JOSEPH M. FARLEY NUCLEAR PLANT, UNIT 1

AMENDMENT TO FACILITY OPERATING LICENSE

Amendment No. 8
License No. NPF-2

ATTACHMENT TO LICENSE AMENDMENT NO. 8

Figure 3.2-3 Rod Bow Penalty (RBP)
 versus
 Region Average Burnup Average

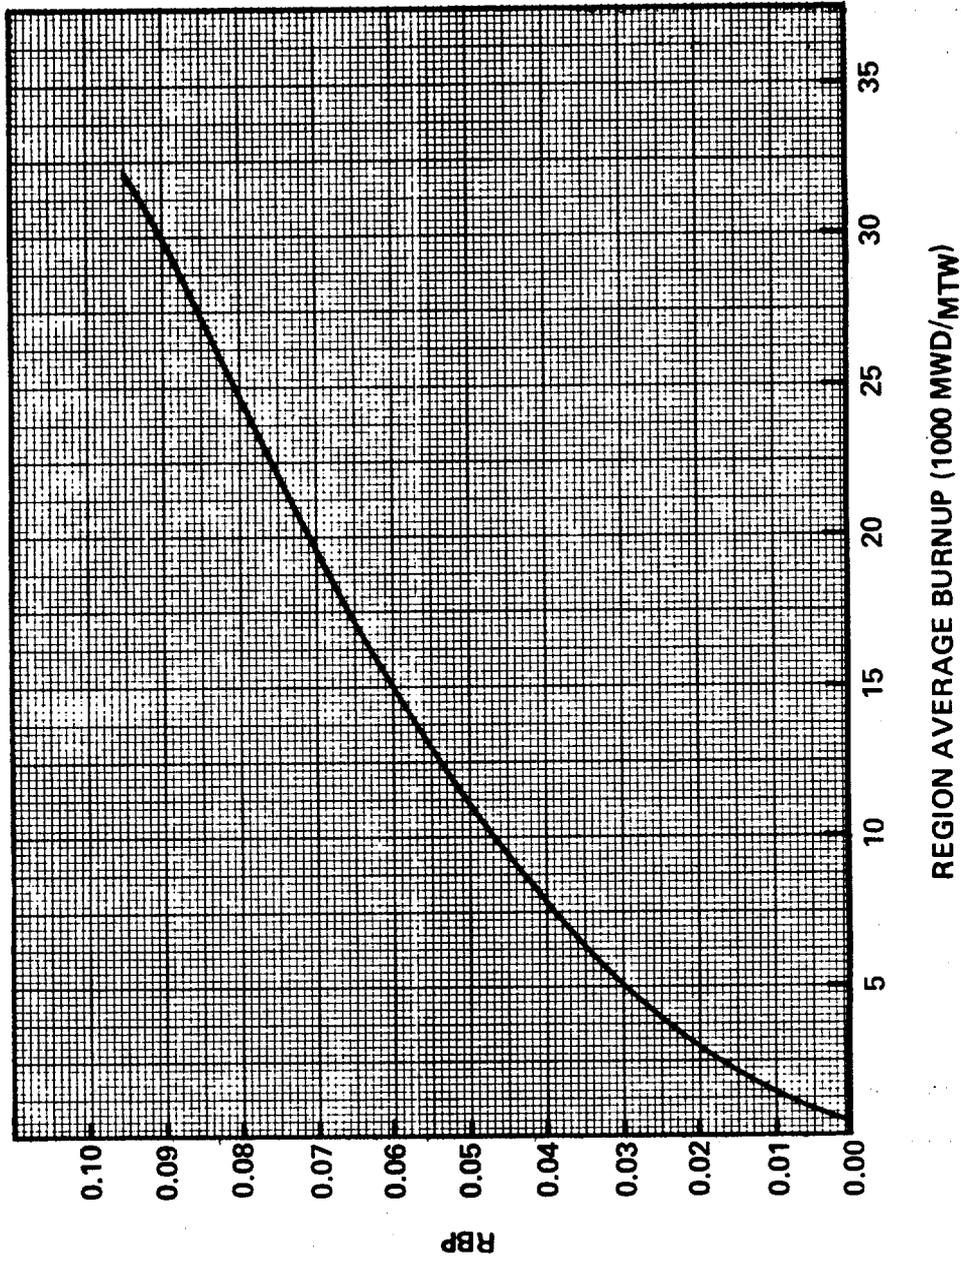
1. Modification to Specification Figure 3.2-3 and Bases 2.1.1 relating to the fuel rod bow penalty for 17x17 fuel designed by Westinghouse.
2. Modifications to Specification 4.5.2 to increase the surveillance on ECCS subsystems (high pressure and low pressure safety injection) in response to our request dated August 30, 1977.

Figure 3.2-3. The existing figure was derived based on a conservative extrapolation of 15x15 fuel data rather than data for the 17x17 fuel existing in the FNP core.

APC proposed a new equation (see Bases 2.1.1) derived by Westinghouse for predicting the amount of rod bow in 17x17 fuel. This new equation is developed from rod bow data from 17x17 lead test assemblies irradiated in the Surry Nuclear Plant Unit No. 1 and Unit No. 2 reactors. The staff has previously accepted this model for the Trojan reactor⁴.

Based on our review of the APC proposal and on the previous evaluation done during the Trojan Nuclear Plant Amendment No. 30 review, we agree the changes are also acceptable for the FNP reactor since it gives a sufficiently conservative estimate of the DNBR reduction.
